Application for Works Approval Amendment

Works Approval Number	W5835/2015/1
Works Approval Holder	Iluka Resources Limited
ACN	008 675 018
File Number	DER2015/000690-1
Premises	North Capel Operations Yearly Road CAPEL WA 6271 Legal description - Mining tenements M70/257, M 70/651 , M 70/959, M70/962, M70/970, M70/978, M70/990, M70/1083 and M 70/1128, M70/279, M70/386 & M70/1 082. As defined by the coordinates in Schedule 1 – Map Works Approval
Date of Report	14 January 2020
Date of Amendment	14/01/2020
Status of Report	Final

Works Approval amendment 2019

Figure 1: Previous proposed location for SR1 stack (2015)

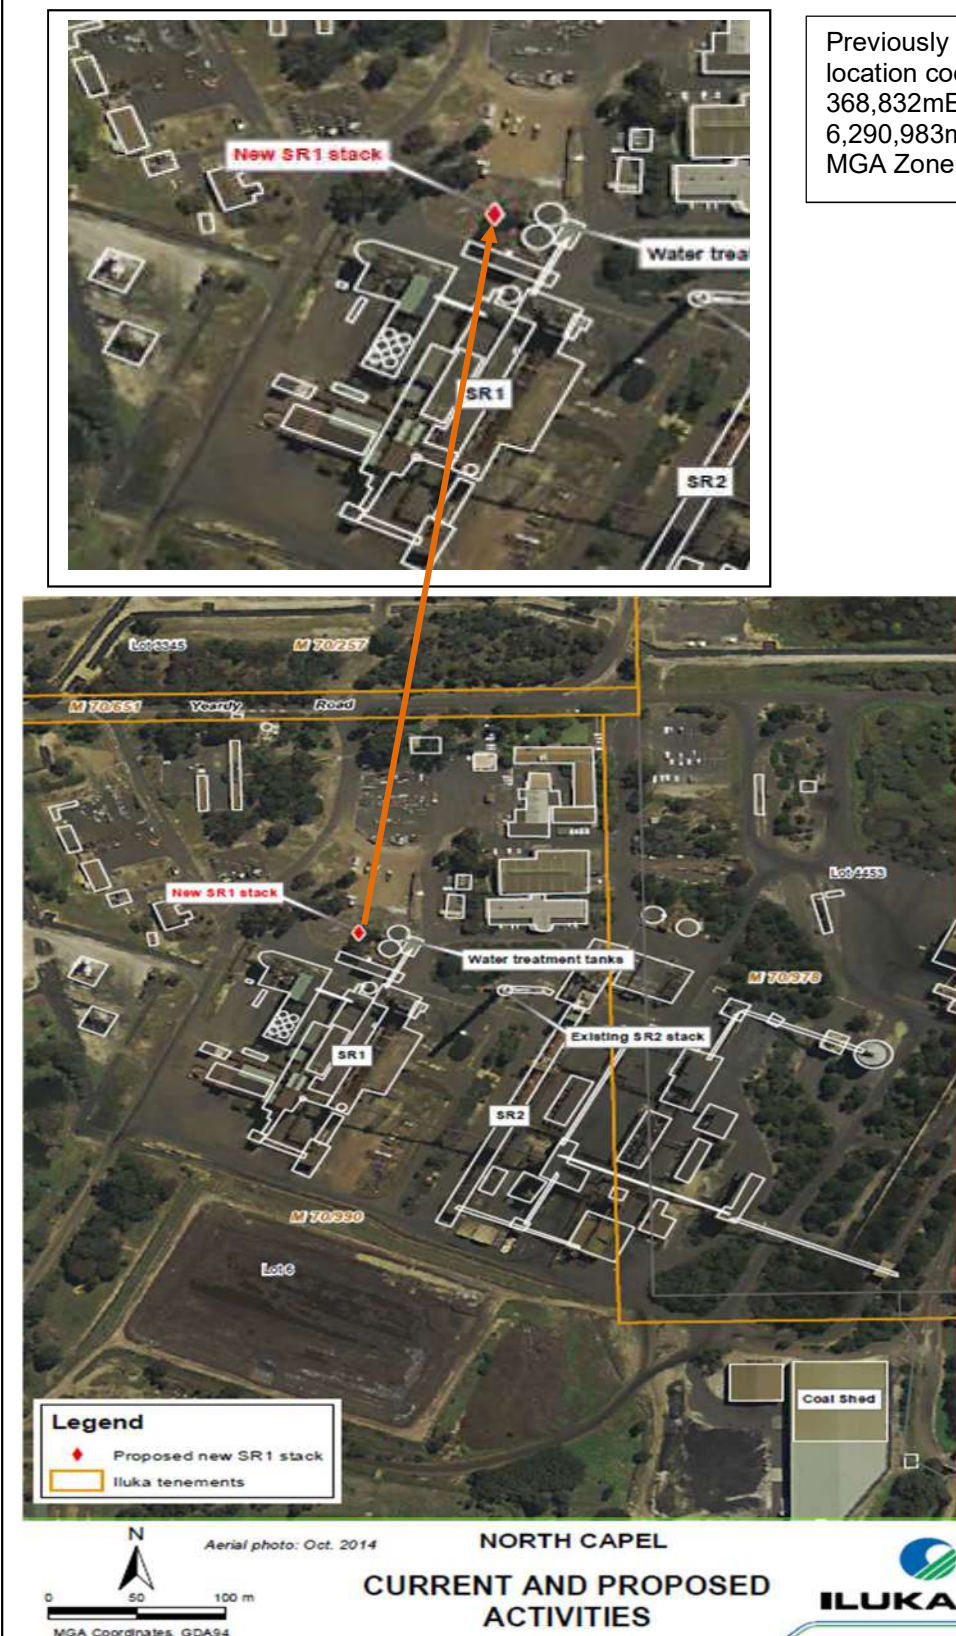
Works Approval Holder's comments – 8 January 2020	DWER decision
Iluka would also like to advise that Figure 2 on Page 5 of the "W5835 Iluka N Capel - draft amended decision report" is referring to the previous location of the "New SR1 stack" and not the new location. Can this be amended as per that shown in the "W5835 Iluka N Capel Plant - draft amended works approval" document.	Figure 2 was removed in the final Decision Report.
Further to the previous email. It has been noted that the end date for the Works Approval has been set at 23/08/2021. Is it possible to have the standard three year duration starting from now? That is, ending January 2023. Given that the start date for the proposal has yet to be decided, and approved, one and half years may not be enough time.	DWER advises the Works Approval Holder that the expiry of issued Works Approval could not be changed at this stage. The issued Works Approval was previously extended in August 2018. DWER advises the Works Approval Holder to apply for amendment closer to expiry date on 23/08/2021.
